Technical Service Bulletin – 55

PCM ASLEEP Warning Banner on C187 Display

Purpose: Correction for intermittent PCM ASLEEP warning banner.

Action: PCM terminal replacement for effected vehicles.

Figure A

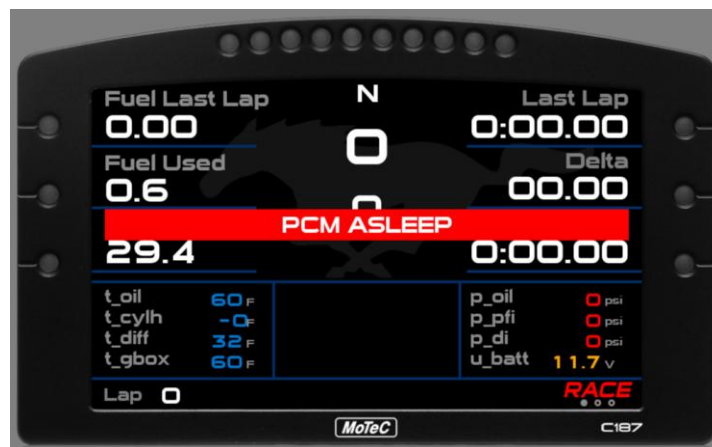
Under certain conditions an alarm banner may be present on the C187 display stating “PCM ASLEEP” (Figure A).

There are situations where this banners is warning of a legitimate fault, and others where the PCM (Powertrain Control Module) has gone into sleep mode. [See Table 1 for more information.](#)

Figure B

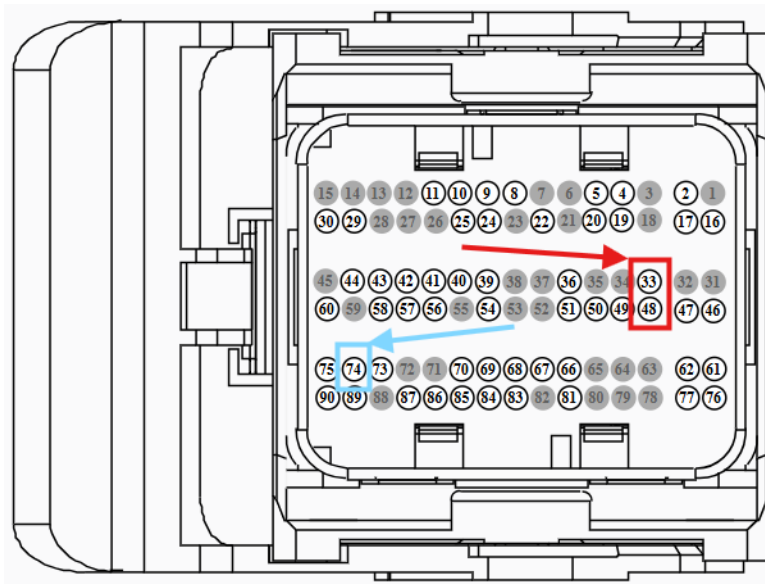
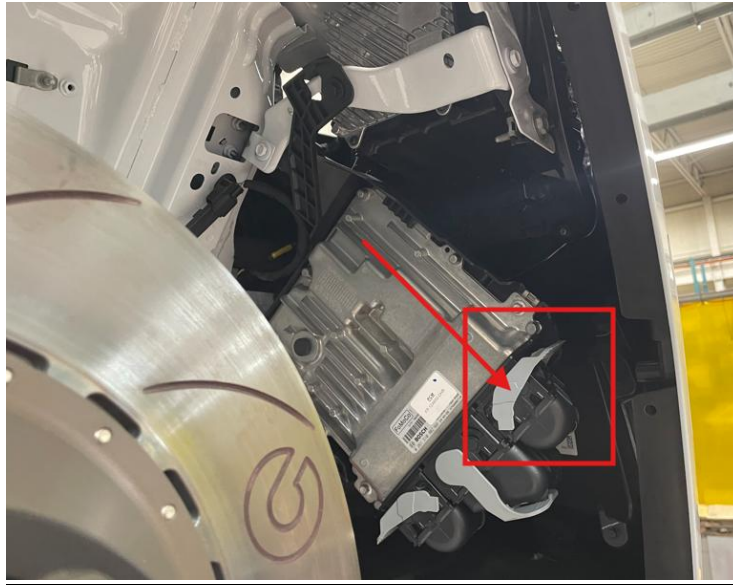
NOTE: On limited occasions there have been spread terminals at the PCM CAN and/or relay control terminals at the PCM which have caused the PCM ASLEEP banner to display on the C187. *Only use the information below if your diagnosis leads you to the circuits outlined. *

PCM CAN circuits can be found at C175B cavities 33 & 48 (circled with RED in Figure B). PCM relay control can be found at cavity 74 (circled with BLUE in Figure B).

The document [*Mustang Dark Horse R_PCM Service Pigtail Procedure found in the Owner Information area on the Competitor Information Page*] details how to remove and replace terminals from the PCM connector bodies with parts available on the parts truck.
